January 2014 Technical Service

Exhaust Flap Actuator Is Loose

F30

F31

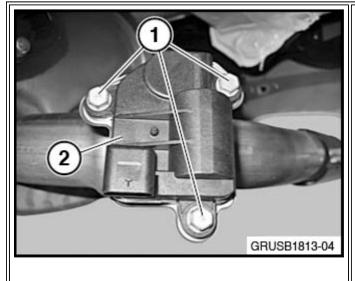
A rattle sound is heard from the back of the vehicle while driving.

The screws holding the exhaust flap actuator to the exhaust have failed.

Replace all three screws (1) for the exhaust flap actuator (2). The replacement screws are an improved design.

Note*: There is heat shield between the exhaust flap and the actuator. It is possible that all three screws have failed and the heat shield is missing. Replace the heat shield if necessary.
